412A - PIPER

Customer Services SERVICE LETTER

SUBJECT:
Muffler and Tailpipe Support

MODELS AFFECTED:
PA-24"250" Comanches only, Serial Nos. 24-2175, 24-2299 to 24-3321 incl., 24-3323 to 24-3394 incl., 24-3396 to 24-3437 incl., 24-3439 to 24-3441 incl., 24-3443, 24-3444, 24-3446 to 24-3457 incl., 24-3459, 24-3460, 24-3462 to 24-3464 incl., 24-3466 to 24-3484 incl., 24-3488 to 24-3536 incl., 24-3538 to 24-3549 incl., 24-3551 to 24-3557 incl.

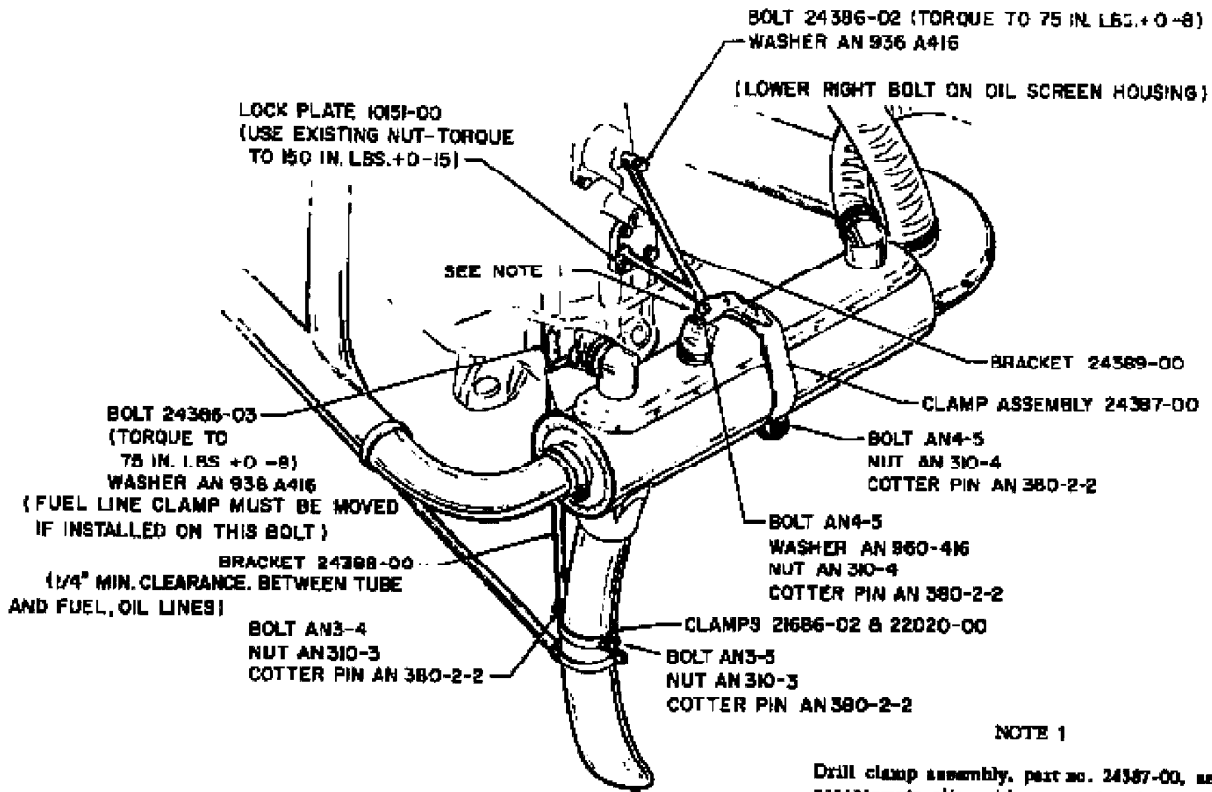
This Service Letter is to advise that a muffler support bracket and a bracket to support the tailpipe are available for installation on the subject aircraft.

These supports are applicable to the PA-24 "250" Comanches within the serial numbers listed above and it is recommended that they be installed on these aircraft as the additional support will be instrumental in extending the service life of the exhaust system.

Drill clamp assembly, part no. 24387-00, as necessary to align with support bracket, part no. 24389-00. Disregard the two tooling holes in the clamp assembly. (Use .250 drill)
